August 6, 2010
NRC3-10-0035

References: 1) Fermi 3
Docket No. 52-033
2) Letter from Jerry Hale (USNRC) to Jack M. Davis (Detroit Edison), "Request for Additional Information Letter No. 36 Related to the SRP Sections 2.5.2 and 2.5.4 for the Fermi 3 Combined License Application," dated June 22, 2010

Subject: Detroit Edison Company Response to NRC Requests for Additional Information Letter No. 36

Figure 2.5.2-214 Earthquake Recurrence Rates for New Madrid Seismic Sources [EF3 COL 2.0-27-A]

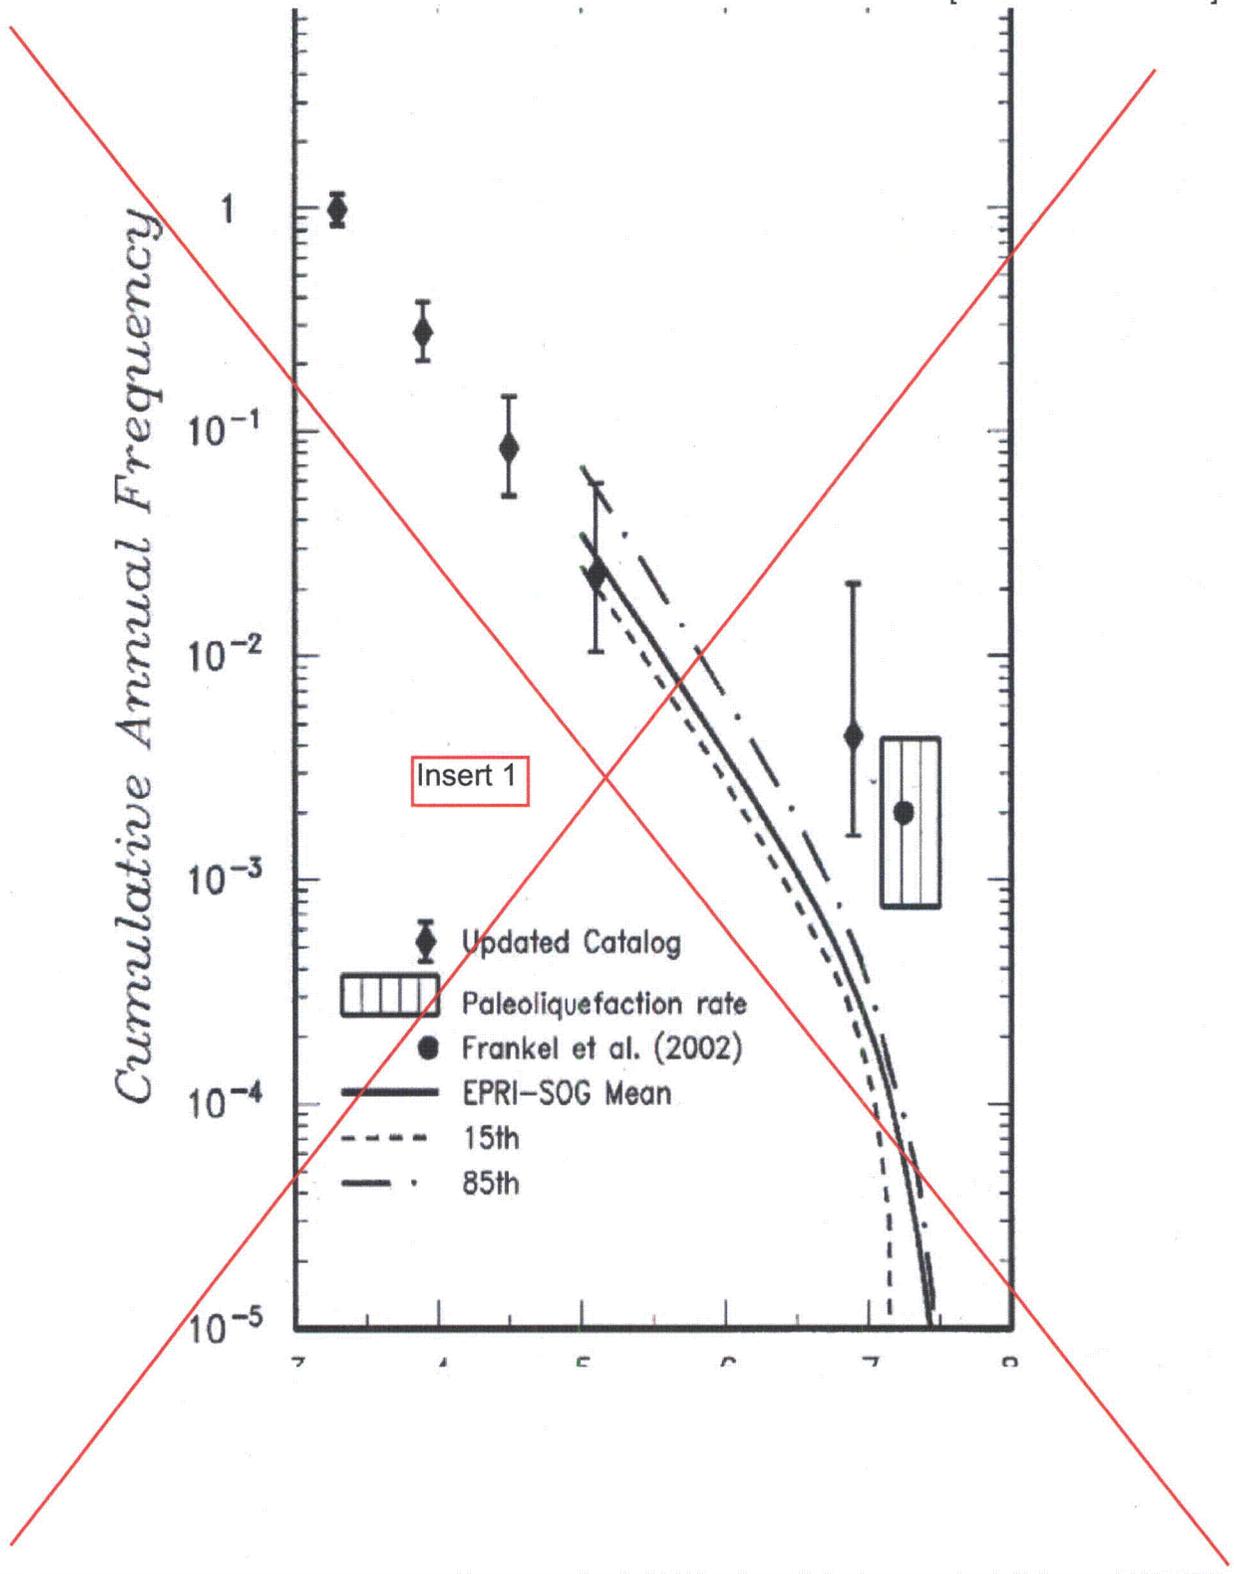
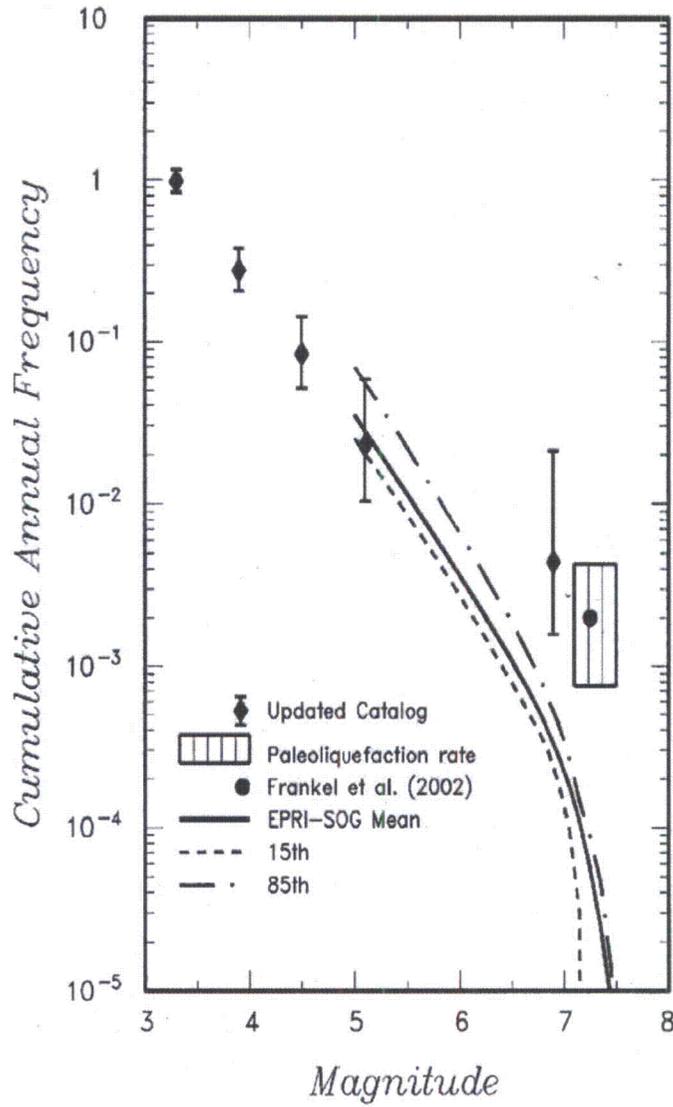
FSAR Section 2.5.2 (Revision 2) includes multiple figures that are either truncated in the lower portions (e.g., FSAR Figure 2.5.2-261, and others) or do not include tick marks on the x axes (e.g., FSAR Figures 2.5.2-222 through 2.5.2-227). Please make the appropriate corrections to these FSAR figures. This request is in accordance with 10 CFR 100.23.

FSAR Figure 2.5.2-214 is revised in this response to fully show the horizontal scale. Figures 2.5.2-237 and 2.5.2-238 are revised in this response to more clearly present the grid lines. Figures 2.5.2-261 and 2.5.2-262 are revised in the response to RAI 02.05.02-14.

Figure 2.5.2-261

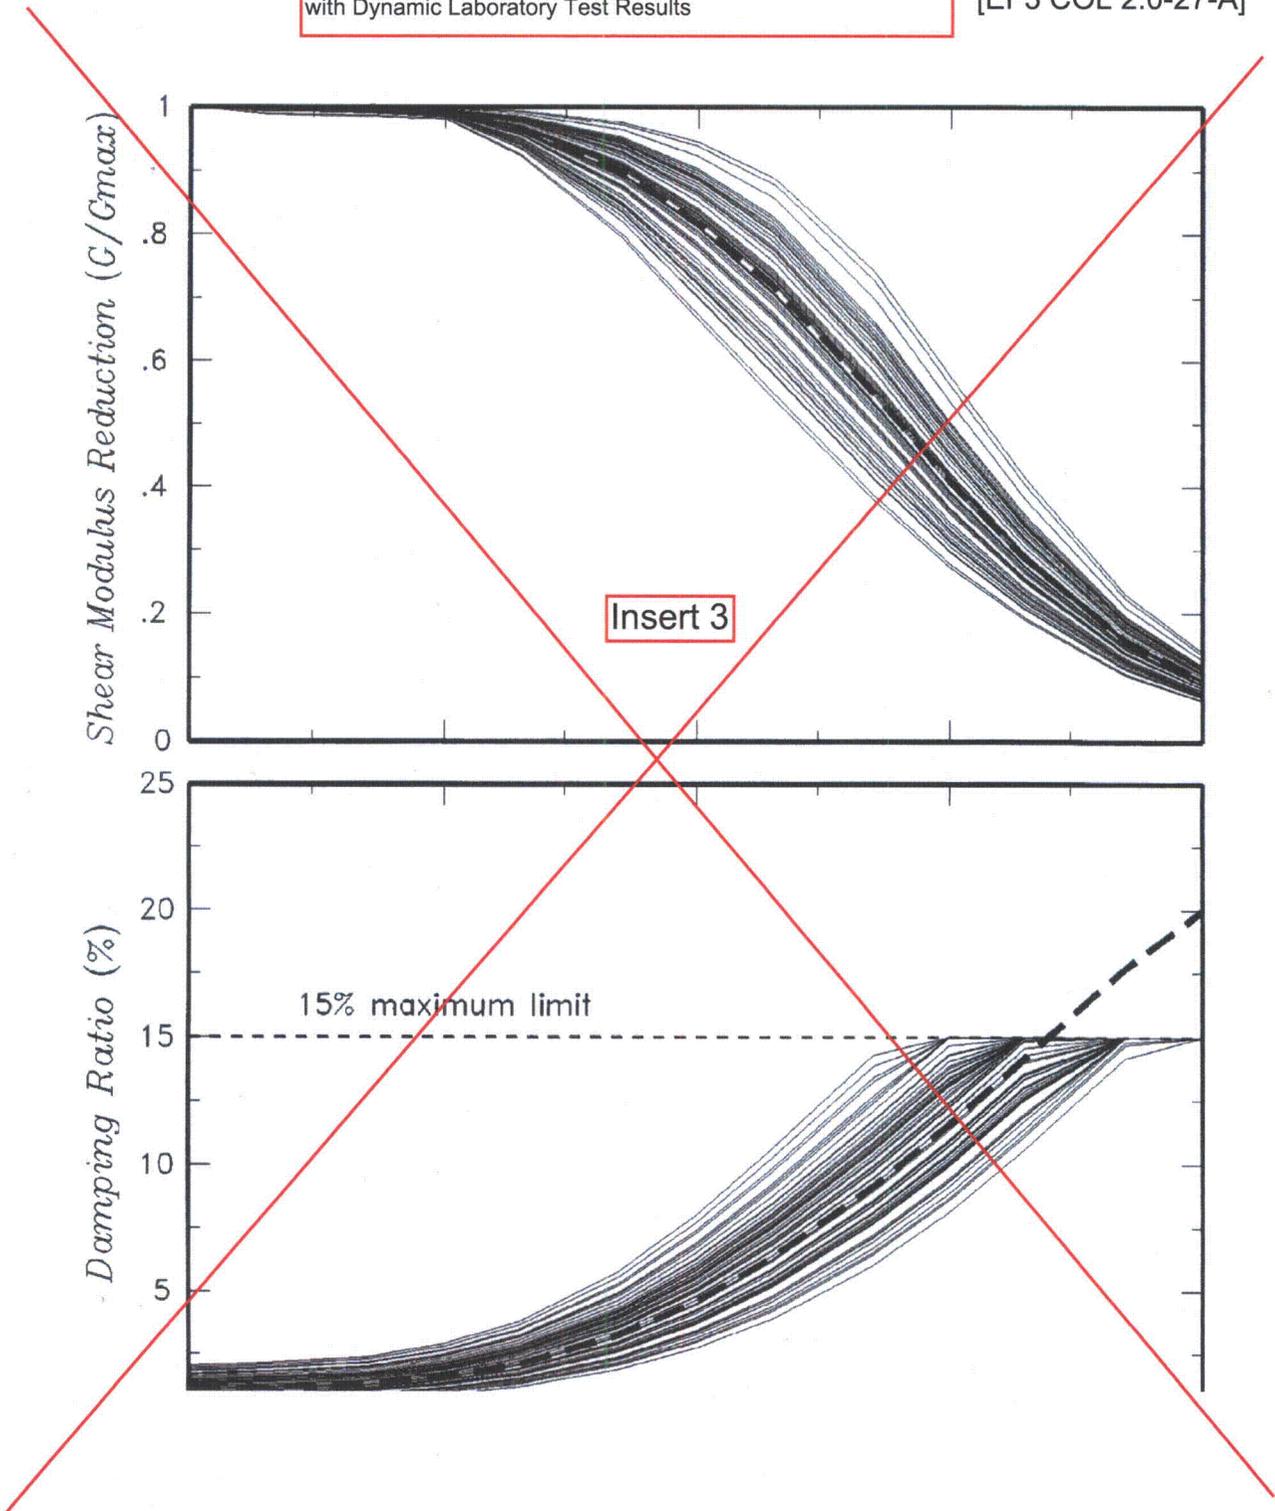
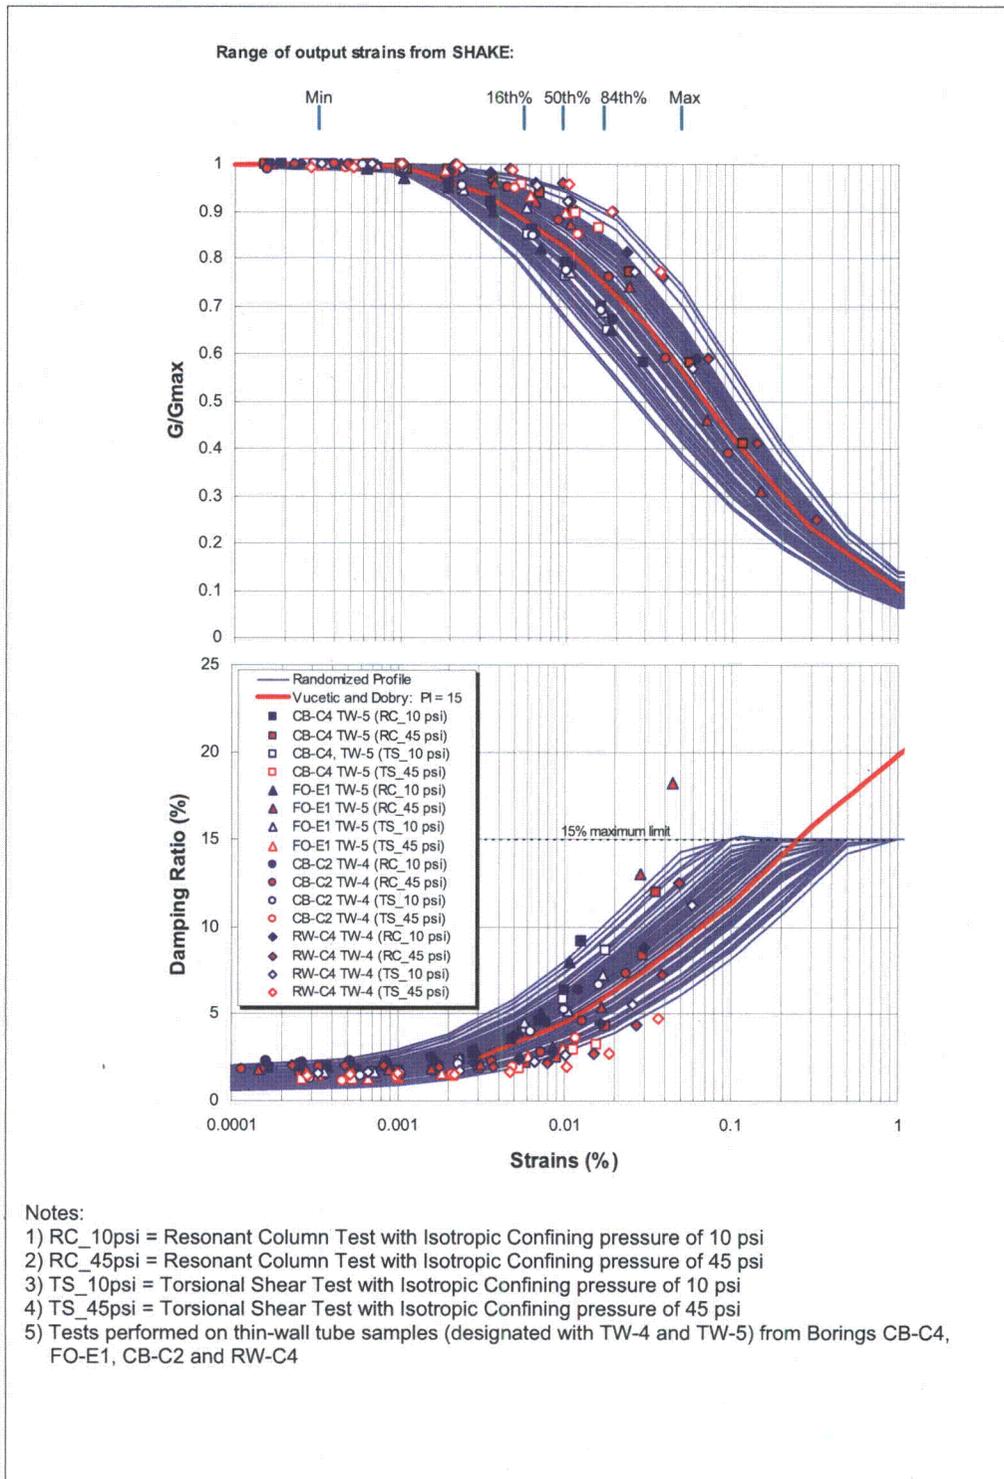
In response to RAI 02.05.02-5, you stated that you conducted the Fermi site response analysis prior to completion of the laboratory dynamic testing performed on the glacial till. Furthermore, you stated that you selected the shear modulus reduction and damping relationships for the glacial till from literature. You then used those literature-based shear modulus reduction and damping curves in your site response analysis. Please update relevant FSAR figures that compare the shear modulus reduction and damping curves used in the site response analysis to the dynamic laboratory test results, similar to the figures provided in response to RAI 02.05.02-5. This request is in accordance with 10 CFR 100.23.

Figures 2.5.2-261 and 2.5.2-262 in the FSAR have been updated to present the dynamic laboratory testing for the glacial till with the damping relationships used in the site response analysis. Figures 2.5.2-261 and 2.5.2-262 in the FSAR are similar to Figures 2 and 3 of the response to RAI 02.05.02-5 in Detroit Edison letter NRC3-10-0002 (ML100130382), dated January 11, 2010. The FSAR has been updated with text that discusses the dynamic laboratory testing, and Figures 2.5.2-261 and 2.5.2-262.

The comparisons on Figures 2.5.2-261 and 2.5.2-262 show that the dynamic laboratory test results for the glacial till fall within the range of the randomized modulus reduction and damping relationships used in the site response analyses.
